## MAYO BRIDGE

### SECTION 2: RIVERFRONT PLAN

**Proposed Bridge**

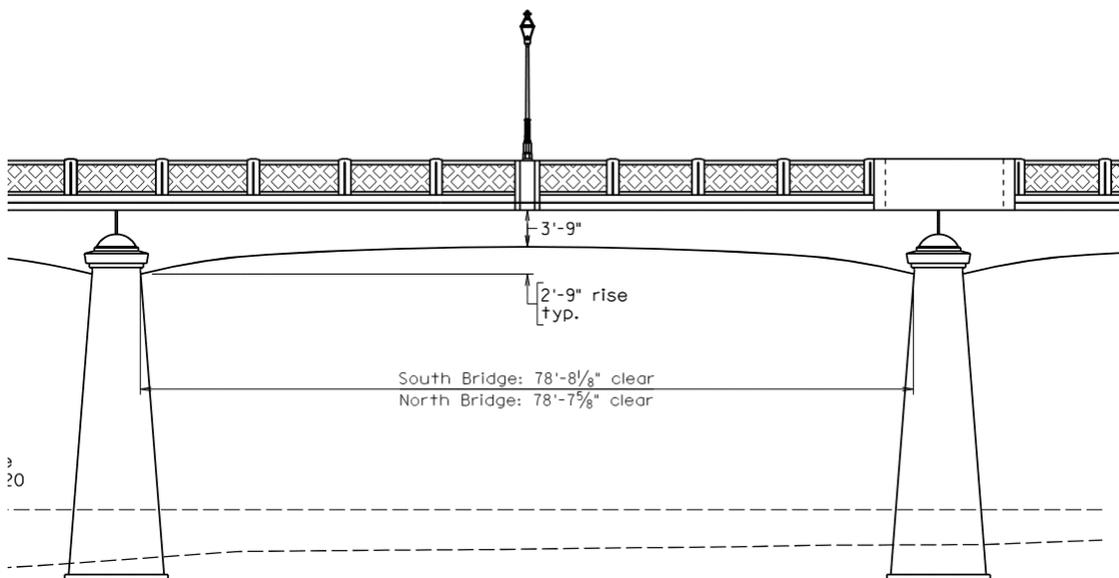
The 1913 Mayo Bridge is the last remaining historic bridge crossing the James River in Richmond. A 2011 analysis and feasibility study has proposed multiple alternatives for the bridge in need of either significant rehabilitation or near total reconstruction. The Mayo Bridge/14th St (U.S. Route 360) is part of the National Highway System. The following guiding principles for the review of the design options available to the City will be followed before any final recommendations are made. Any rehabilitation or reconstruction of the Mayo Bridge will:

- Maintain the historically accurate architectural appearance of the existing Mayo Bridge.
- Implement historically accurate architectural lighting fixtures for the Bridge.
- Install wider sidewalks to accommodate pedestrians and other activities (e.g., fishing, sightseeing, etc.)
- Safely accommodate all forms of transportation across the bridge including:
  - Pedestrians and bicycles
  - Vehicular traffic
  - Existing public transit and potential future transit options
- Use the existing access doors in the flood wall
- Provide access to Mayo Island
